COMMISSION FOR  
HISTORICAL & ARCHITECTURAL  
PRESERVATION

STAFF REPORT

**REQUEST:** Construct rear/rooftop addition with front deck/balcony

**ADDRESS:** 223 E. Churchill Street (Federal Hill Historic District)

**Image 10: 223 E. Church Street – Proposed East and North Elevations**

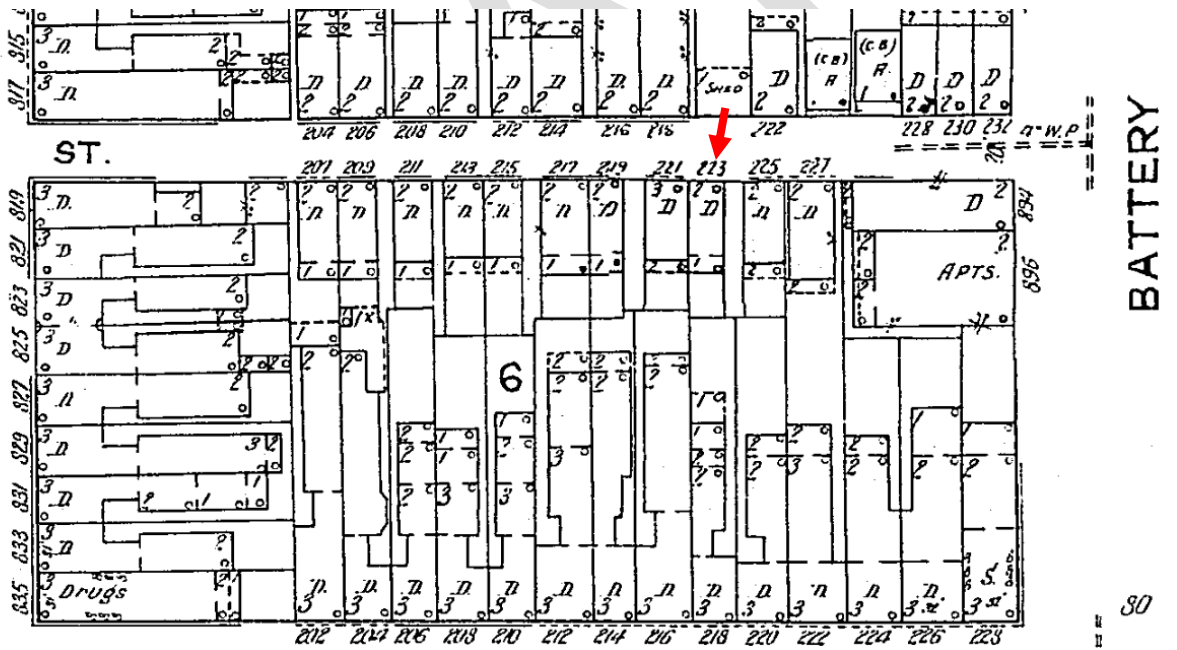
The windows at the front of the third floor addition will be large sliding glass doors. Glazing will also line the narrow strip of the addition that hangs over the side walkway. At the east elevation, an existing window about midway back on the first floor of the original building will be removed and infilled and a new window opening created farther to the rear. A window in the existing first floor rear addition will be replaced with a new window in the same opening. At the rear, a new glass sliding door at the first floor and a new narrow fixed pane window will be inserted in the new addition. These are contemporary treatments to a contemporary addition. The windows and doors meet the design guidelines.

In the original plan, the balcony at the third floor extended over the ridgeline at the front. In the revised plan the balcony is behind the ridgeline. It will have a glass railing. It is accessed from interior stairs. The roof deck guidelines say new roof decks must not be visible from the street-front grade along any primary elevation. Based on sightline studies provided by the architect, the balcony will not be visible from the street, but portions of the sidewalls and roof over the recessed balcony will still be visible. The plan partially meets the guidelines.

**Image 11: 223 E. Churchill Street – Building Section – Sightline Study**

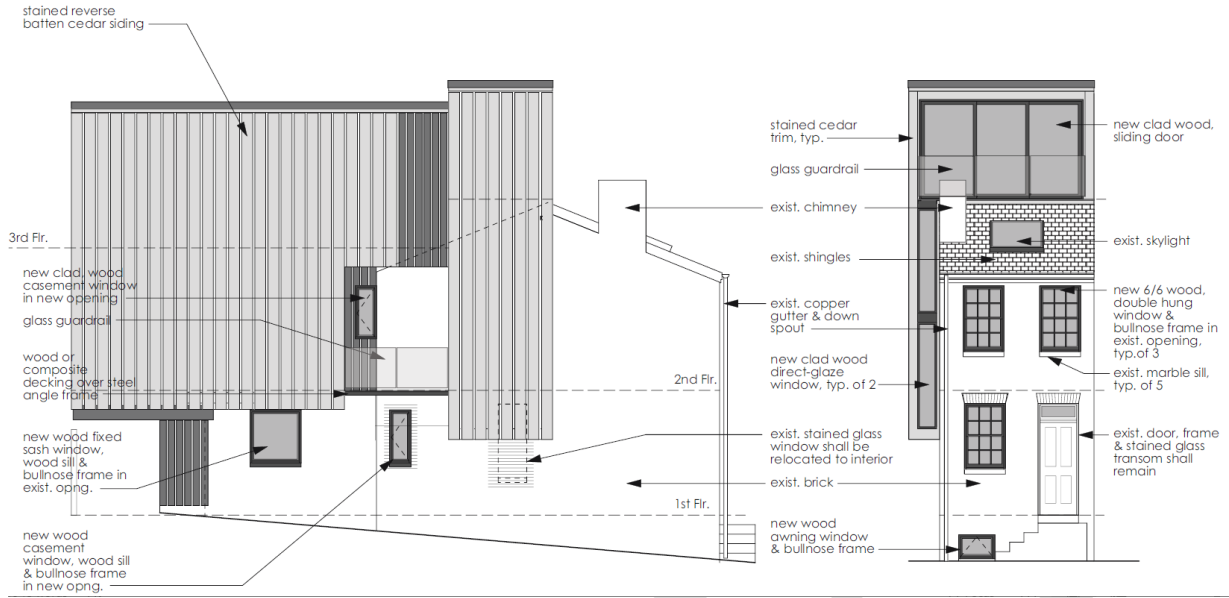
CHAP design guidelines state that roof top decks *must not* be visible from the street-front grade along any primary elevation. The sightline studies show that some of the new construction will be visible, mainly the walls and roof surrounding the recessed balcony. As a building addition with a rooftop component, the plans meet most of the design guidelines.

Image 12: 223 E. Churchill Street – Existing (left) and Proposed Rendering (right)

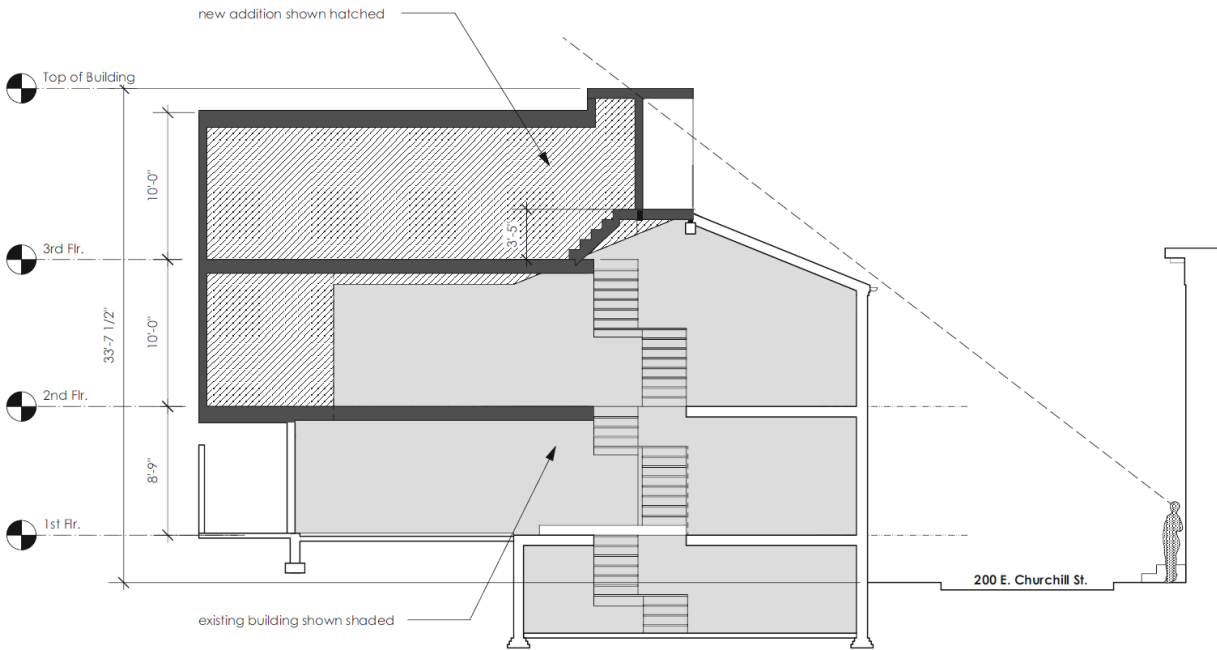
The design is a contemporary one. The addition is most visible from the front when viewed looking down the side walkway. The majority of the addition is at the rear, and so it partially meets the design guidelines.

All of the houses on this block are two-story houses, with one exception. 221 E. Churchill Street, the abutting neighbor on the west side of 223 E. Churchill, is three stories high, but is only a half story taller, because it is built at street grade, and 223 E. Churchill has a raised first floor. The early Sanborn maps label 221 E. Churchill as a store. The scale of this proposal is somewhat mitigated by being adjacent to the three-story house. The bulk of the mass of the addition is at the rear. The removal of the balcony suspended over the ridgeline is an important step in the right direction. The third floor recessed area with its sidewalls and roof is visible when looking at the front elevation. The design mostly meets the guidelines.
